PLANNING COMMISSION

AGENDA

**STAFF REPORT
DOWNTOWN OVERLAY DISTRICT REVIEW**

**CASE NO: OAR21-001
PROPERTY: 1376 3RD AVE**

1 FRONT FACADE PROPOSAL PLAN
A1.01 SCALE 1:16

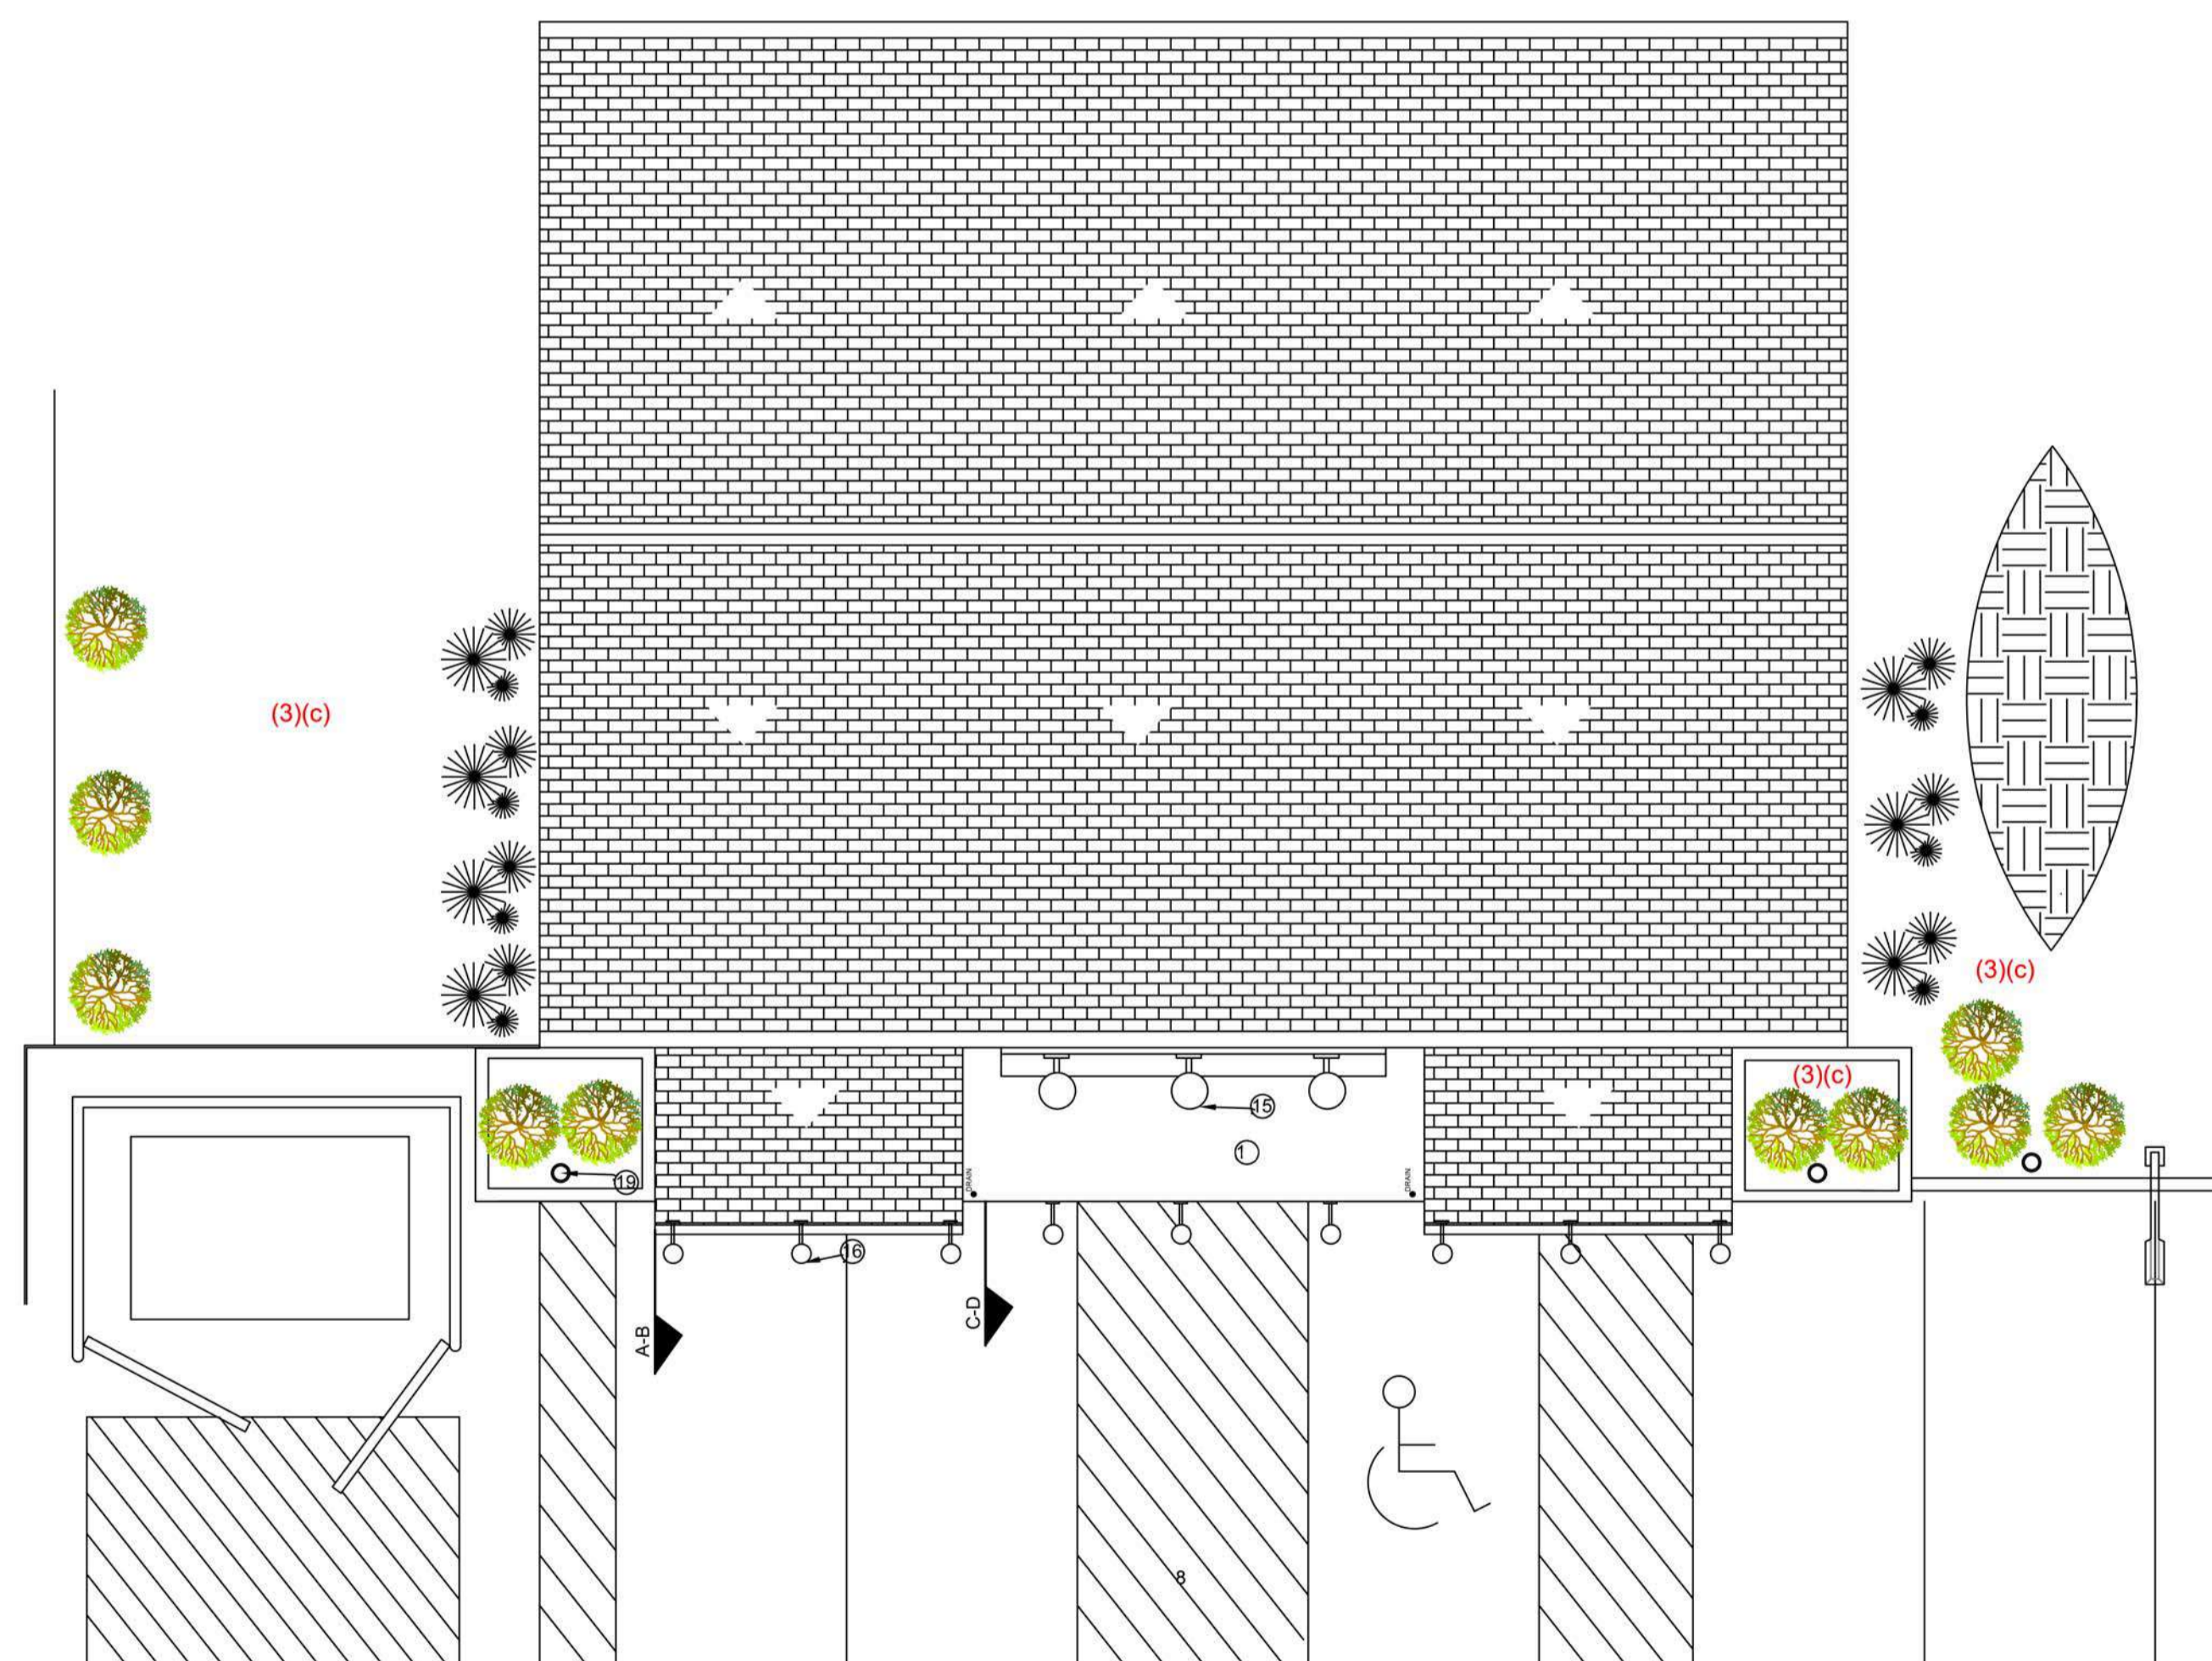
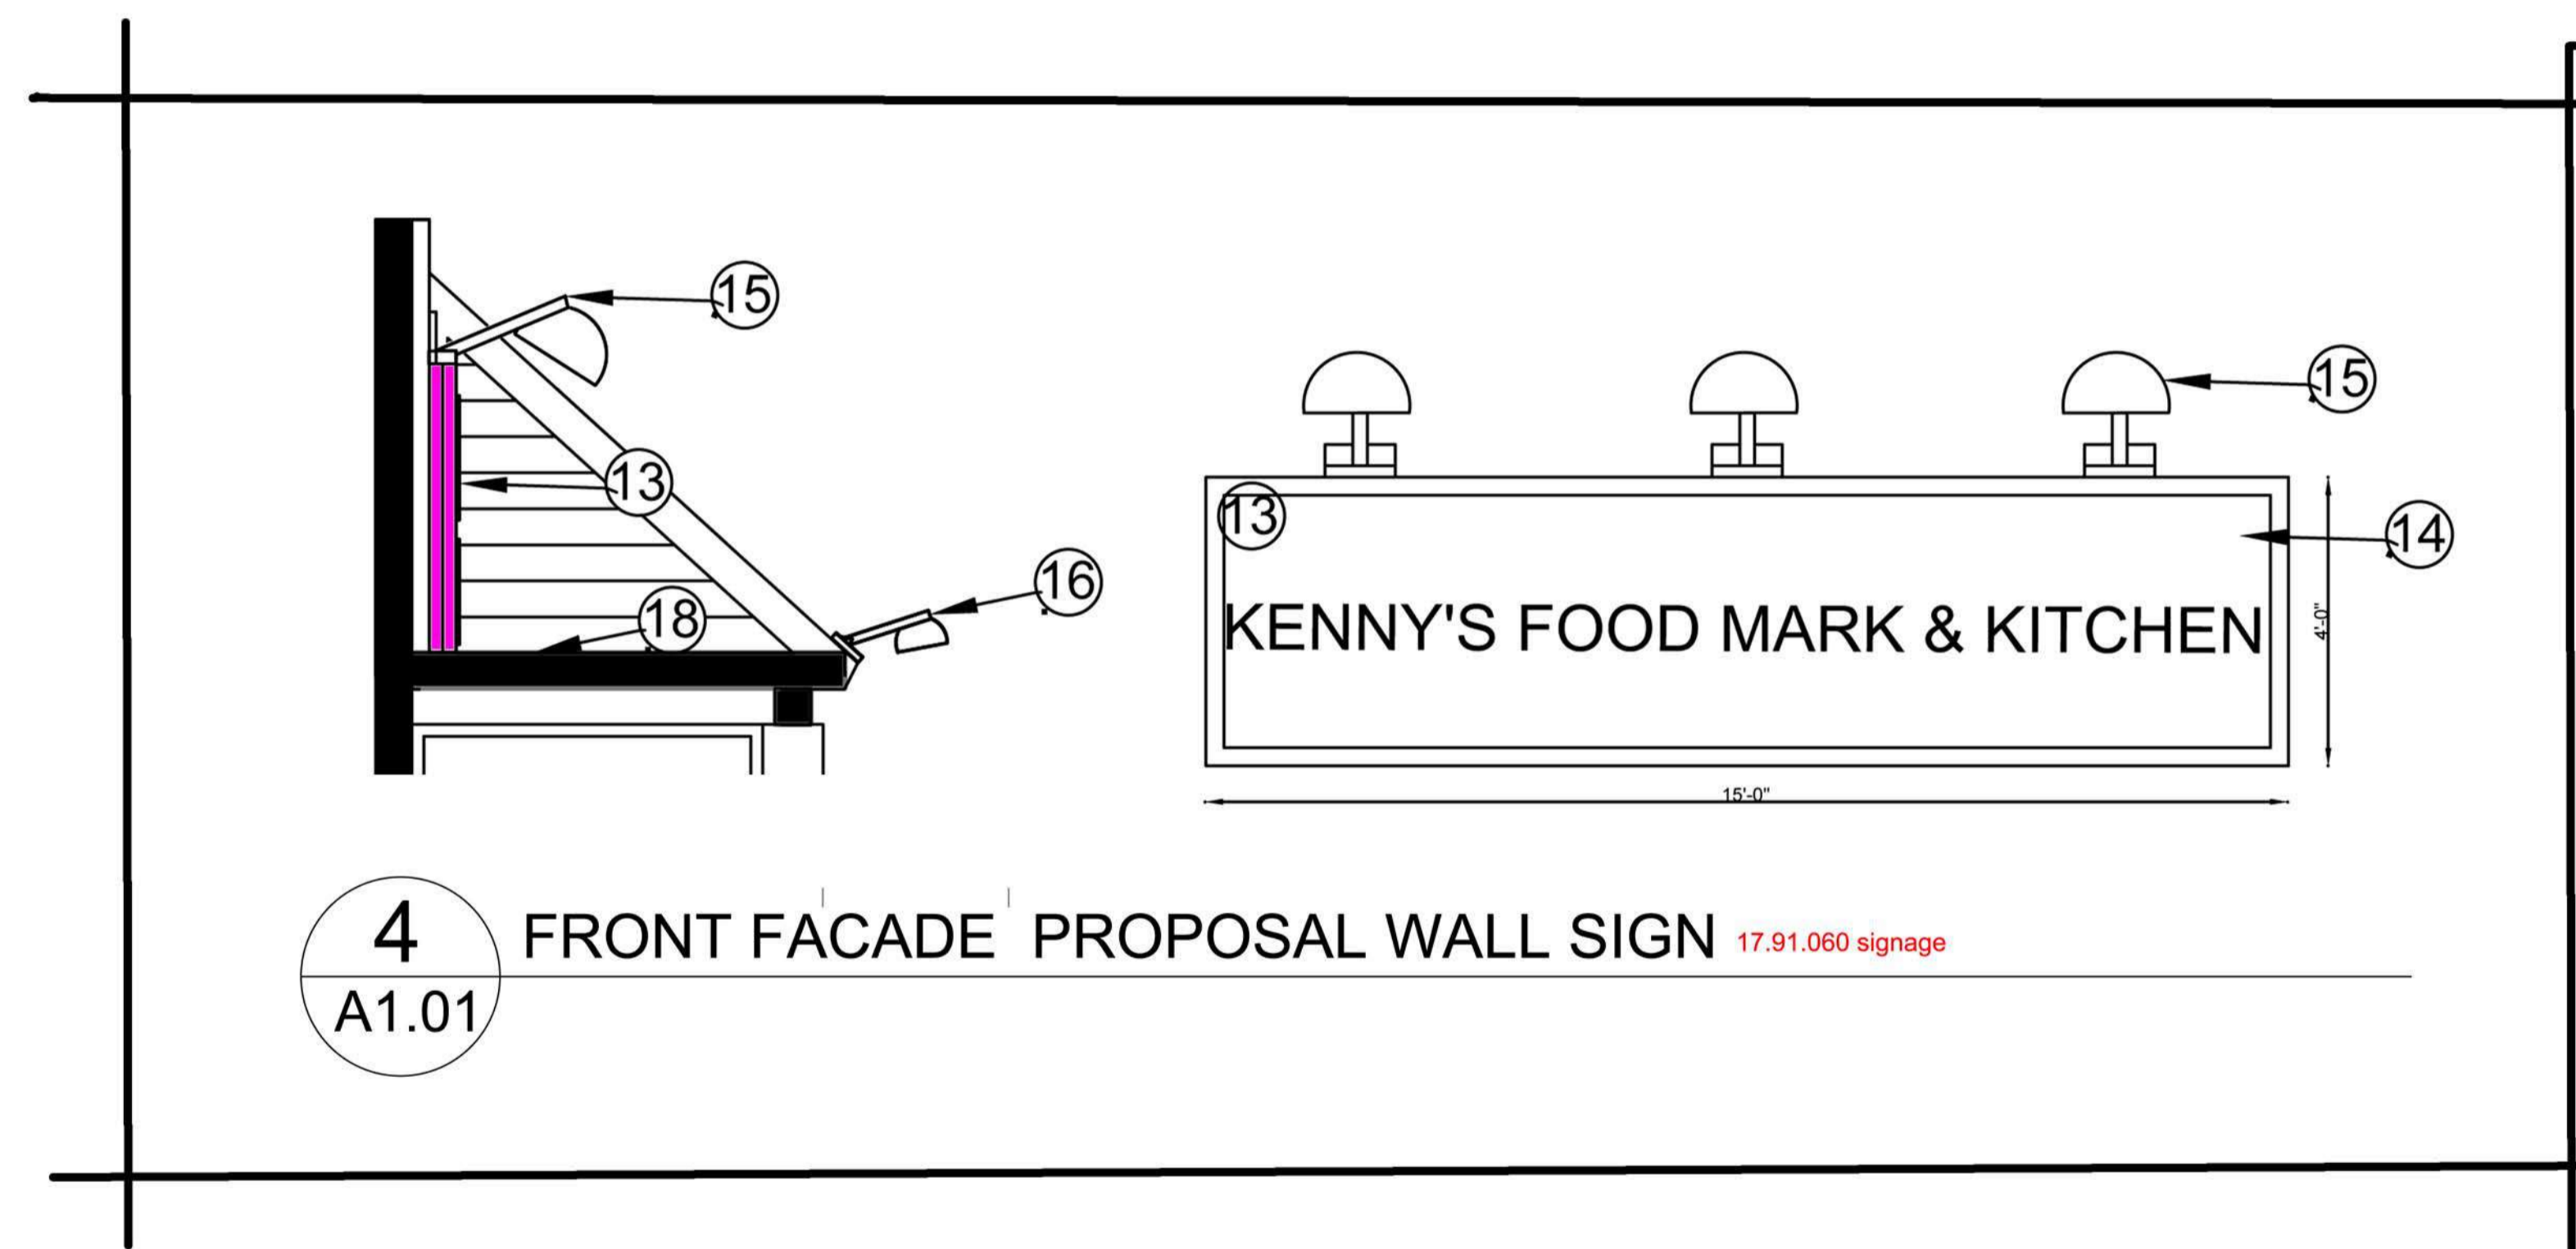
(2)(b)	Minimum of 75% of street-facing façade must be comprised of clear windows that allow views of indoor space or product display areas.	No
(2)(c)	Use of bare metal, aluminum siding, metal panels, plastic, and mirrored glass shall be prohibited.	No. Existing building consists of aluminum metal siding and roofing.

(3)(c)	Open areas shall be landscaped. Provide foundation plantings adjacent to the building.	No. No landscape plans were submitted.

(3)(d)	Sidewalks and parking areas shall be properly lighted to facilitate safe movement of pedestrians and vehicles.	No. No lighting plans were submitted.

(4) Awnings	n/a	A covered porch is proposed rather than awnings.
(5)	Exterior lighting must be placed and shielded so as to direct light onto the site and away from adjoining properties. Floodlights, wall pack units, other types of unshielded lights, and lights where the lens is visible outside of the light fixture shall be prohibited, except where historical-style lighting is used that is compatible with historic-style street lamps installed by the City. Neon lighting as accent lighting is prohibited.	No. No lighting details or plans were submitted

(7)(a) Landscaping	Provide street trees at 25' increments.	No. No tree plan was submitted.

(7)(b)	Landscape Plan shall be submitted for review and approval.	No. No landscape plan was submitted.
(8) Setbacks	Max front yard setback shall be 10'. Side yard setback may be zero (0) where buildings meet fire codes. Minimum rear setback shall be 5'.	No. Existing building does not meet current requirements for front setbacks. However, existing building setbacks may be appropriate on the subject site.
(9) Building Height	Shall not exceed 45' or three stories.	Yes
17.91.060 Signage	Roof top signs are prohibited	No. Renderings show a roof top mounted sign. No other sign details were submitted. Applicant must submit a sign permit application for review by the Planning Commission.

1. Site plan and building design shall generally conform to the plans for "1376 3RD AVE - KENNY'S GROCERY" dated 10/06/2021.
2. Site improvements shall meet all applicable Downtown Overlay District and Development Regulations of the City of Auburn.
